2505-068
4703 88th Ave SE
Mercer Island
TV inspection report.

To the attention of Ruji Ding, City of Mercer Island

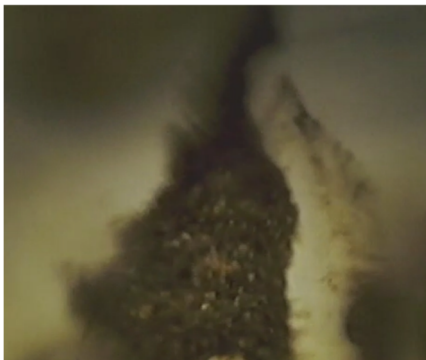
The video inspection from downspout 5 going downstream shows sediment and standing water in the 6" conveyance pipe. The pipe between downspout 6 and the two 90 degree bends downstream from there was holding water that appeared to be 1" – 2" deep (less than 1/3 of the pipe).

The retained water ends prior to the first of the two bends gradually, indicating that this portion of the pipe is sloping backward. There is also a fair amount of sediment at the bottom of the pipe along this section. The sediment should be removed and the pipe slope adjusted to provide positive drainage.

While the portion of the pipe that is not submerged may have capacity to convey the runoff from the project, the sedimentation in place indicates that it will continue to accumulate, eventually blocking the pipe in this location.

At the first of the two 90 degree bends in the north corner of the house, we observed a fairly small, but lodged wooden obstruction. The wooden obstruction should be removed.

1. Flush system and remove rocks, sediment and other debris from the downstream catch basin.
2. Adjust the pipe slope at the north corner of the house to allow gravity flow at 2% slope.

We trust this analysis will provide the information needed to allow this project to proceed. While there were locations within the pipe that had retained rocks and sediment, a flush of the system should result in clearing those obstructions. Removal of the wooden obstruction can be accomplished while the slope of the reverse sloped pipe is being adjusted in that same corner.
